*TOLEDO CITY
PLAN COMMISSION
REPORT*

December 5, 2013

**TOLEDO-LUCAS COUNTY PLAN COMMISSIONS
APPLICATION DEADLINE, AGENDA, STAFF REPORT AND HEARING
SCHEDULE - 2013**

SITE PLAN

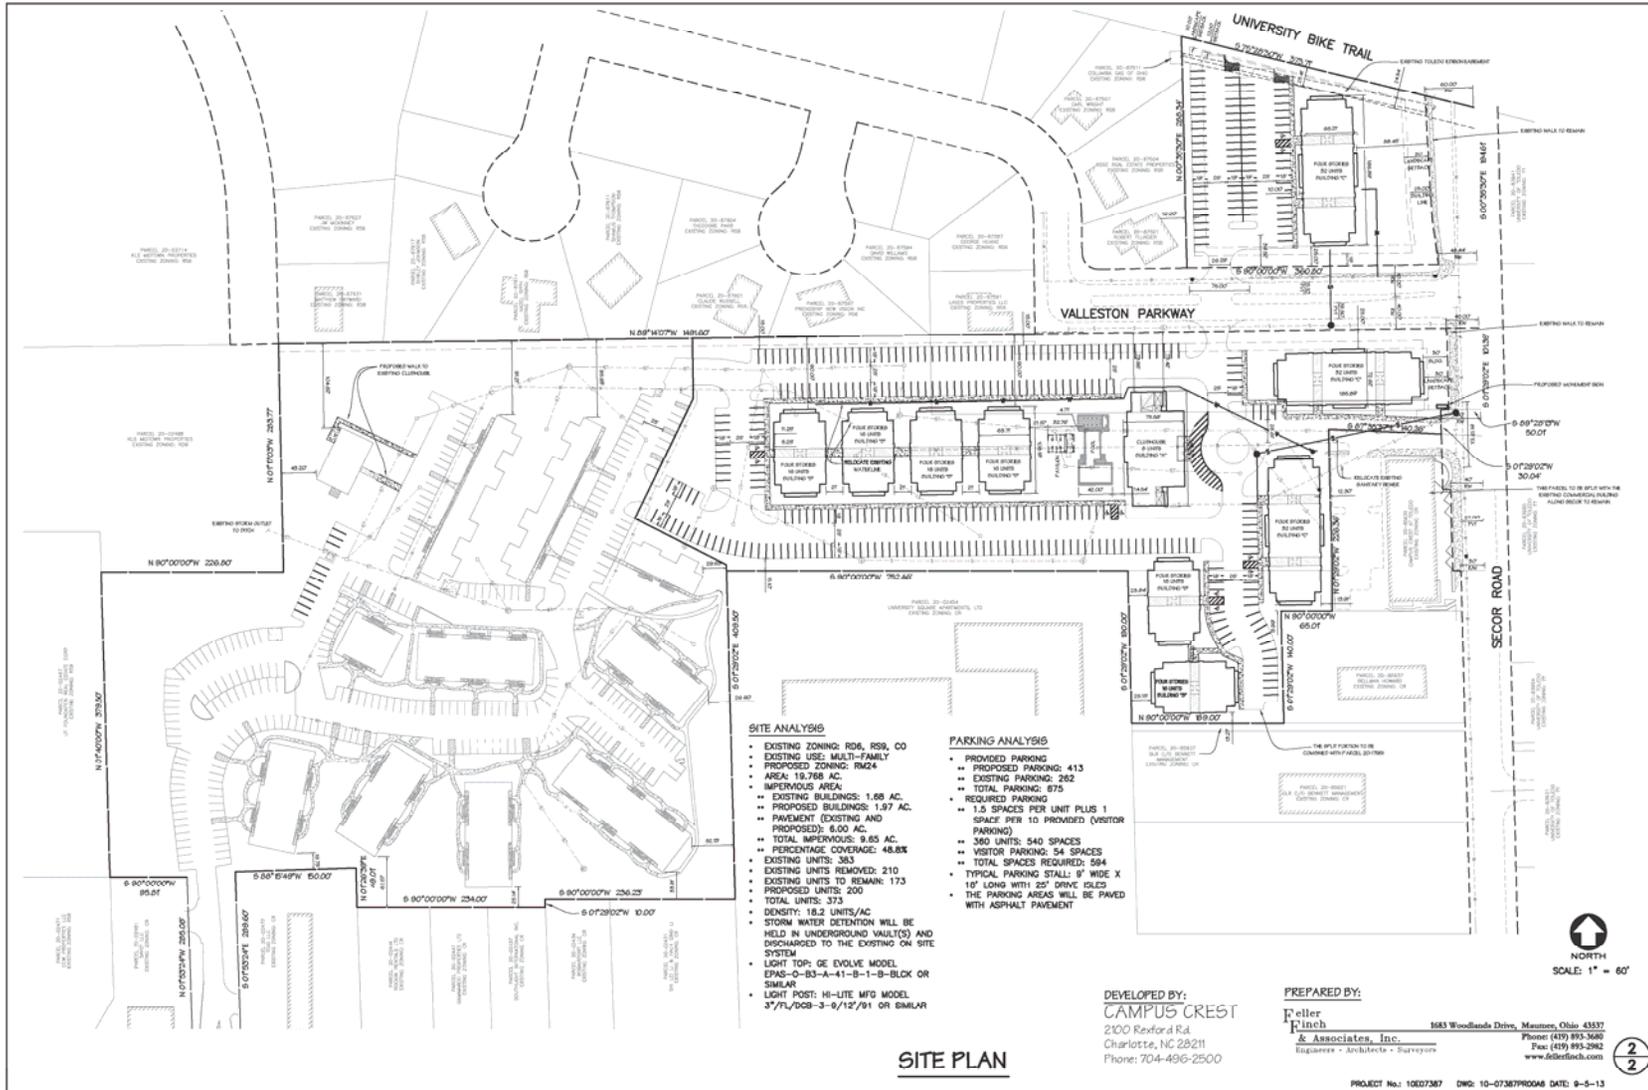
31. Maximum building height is not permitted to exceed 51 feet. This height is subject to approval of the height waiver included with the companion zone change.

32. Gross parcel acreage coverage shall not exceed 50% by buildings, street pavement, driveway pavement and parking area pavement. This coverage is subject to approval of the coverage waiver included with the companion zone change.

33. The applicant shall submit a revised elevation that identifies all exterior materials to be used and the percentage of materials per façade. All building facades visible from any right-of-way shall consist of a minimum 75% high quality materials.

35. A concrete curb or permanent wheel stops shall be constructed along the edge of all parking spaces adjoining landscaping area.
36. Dumpster location(s) shall have a concrete pad and be surrounded by a solid wooden fence or a masonry screen enclosure with landscaping and shall not be located in any required setbacks, **shall be noted on revised site plan.**

- b. Total interior landscaping shall be 20 square feet per parking space. Landscape areas within the parking area shall be peninsular or island types and must be constructed with 6 inch by 18 inch concrete curbing; **shall be noted on revised landscape plan.**

- c. All parking spaces must be within 100 linear feet of a landscaped area; **shall be noted on revised landscape plan.**
- d. All landscaped areas must have a minimum dimension of at least 9 feet and be at least 160 square feet in area; **shall be noted on revised landscape plan.**

- e. Topsoil must be back filled to provide positive drainage of the landscape area; **shall be noted on revised landscape plan.**
- f. Landscaped areas may not contain bare soil, aggregated stone or decorative rock. Any ground area must be covered with hardwood mulch, grass or other vegetative ground coverage; **shall be noted on revised landscape plan.**

- g. Landscape terminal islands must be provided at the end of each parking row; **shall be noted on revised landscape plan.**
- h. Two canopy trees and six shrubs are required to be installed in interior landscape areas for each 10 parking spaces within the parking lot; **shall be noted on revised landscape plan.**

SITE PLAN

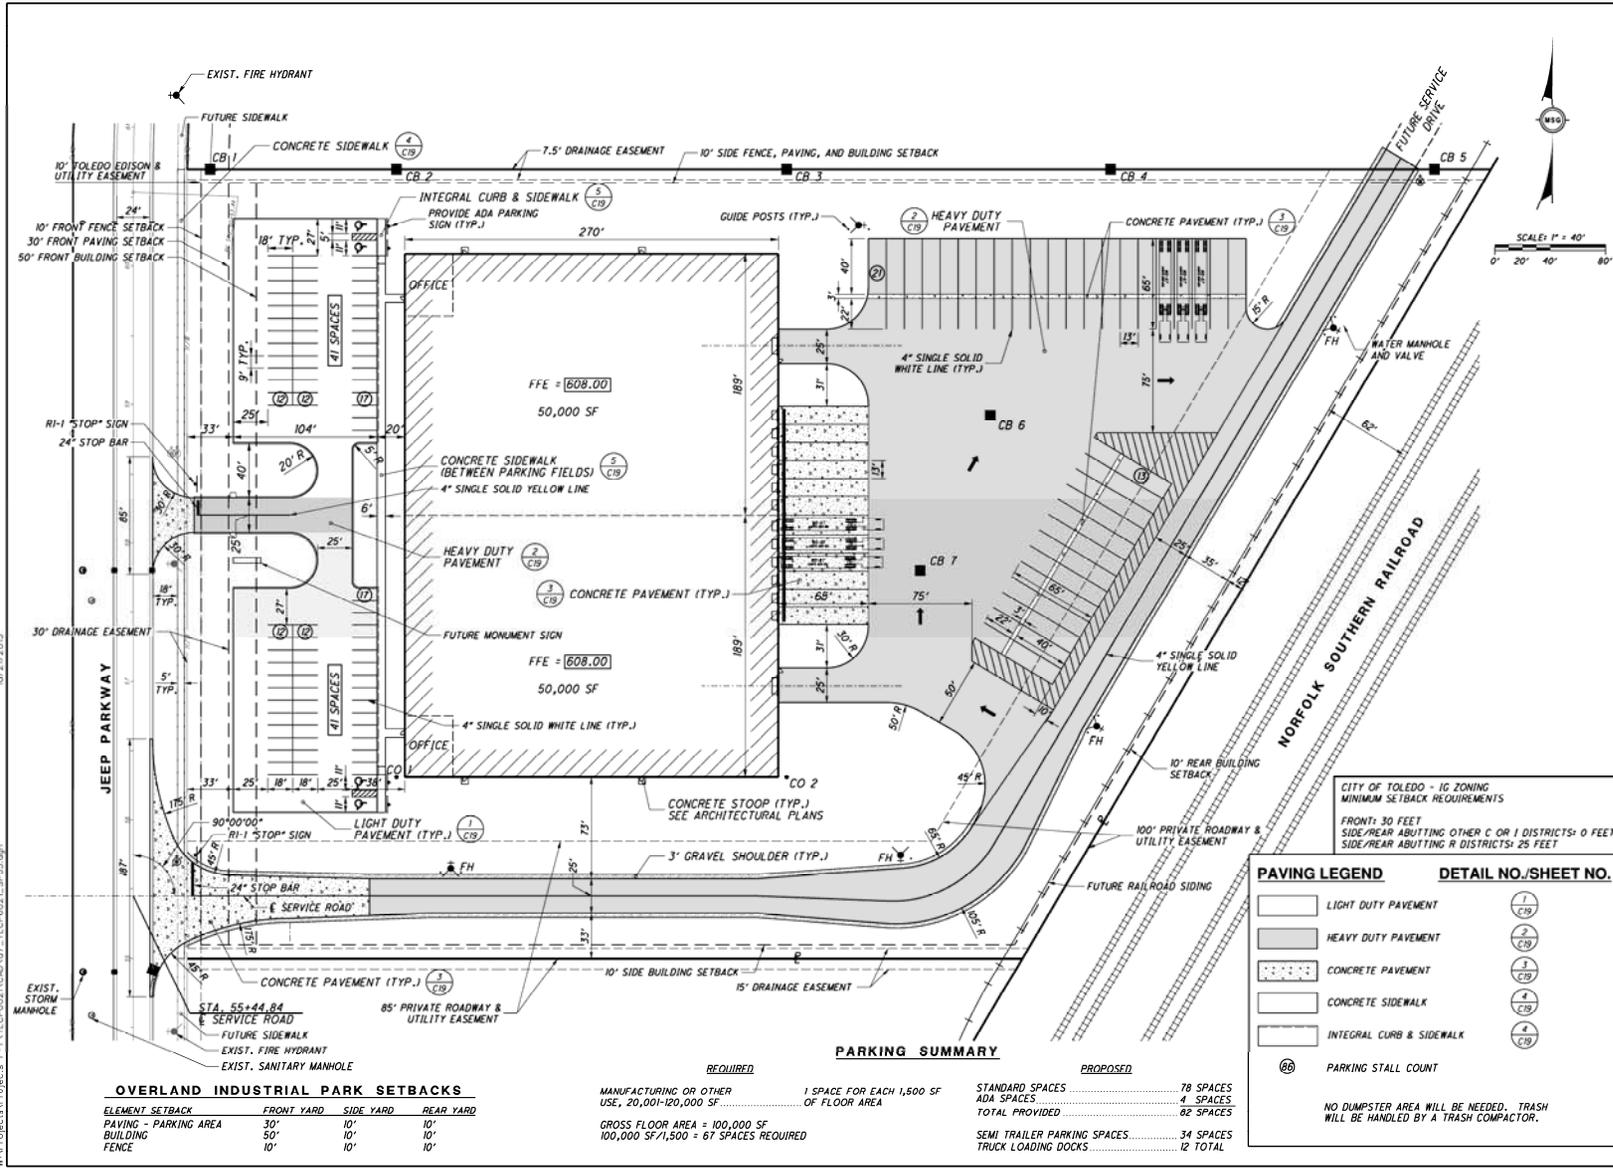
- a) A 30' Greenbelt is required along the Jeep Parkway frontage and shall include one tree for every 30' of lot frontage and a solid evergreen hedge; **acceptable as depicted on landscape plan.**

- b) Landscaped areas may not contain bare soil, aggregated stone or decorative rock. Any ground area must be covered with hardwood mulch, grass or other vegetative ground coverage; **acceptable as depicted on site plan.**

- e) The location, height and materials for any fencing to be installed and maintained; **acceptable as depicted on site plan.**
 - f) The location and direction of any proposed lighting (lights are to be directed away from adjacent residential properties); **acceptable as depicted on site plan;** and

- g) The location, lighting and size of any signs; **acceptable as depicted on site plan.**
- 26.A Bond of Performance or suitable assurance acceptable to the Division of Inspection valid for a period of two (2) years shall be posted with the Commissioner of Inspection providing for the installation of required landscaping within one (1) year. Landscaping shall be installed & maintained indefinitely.
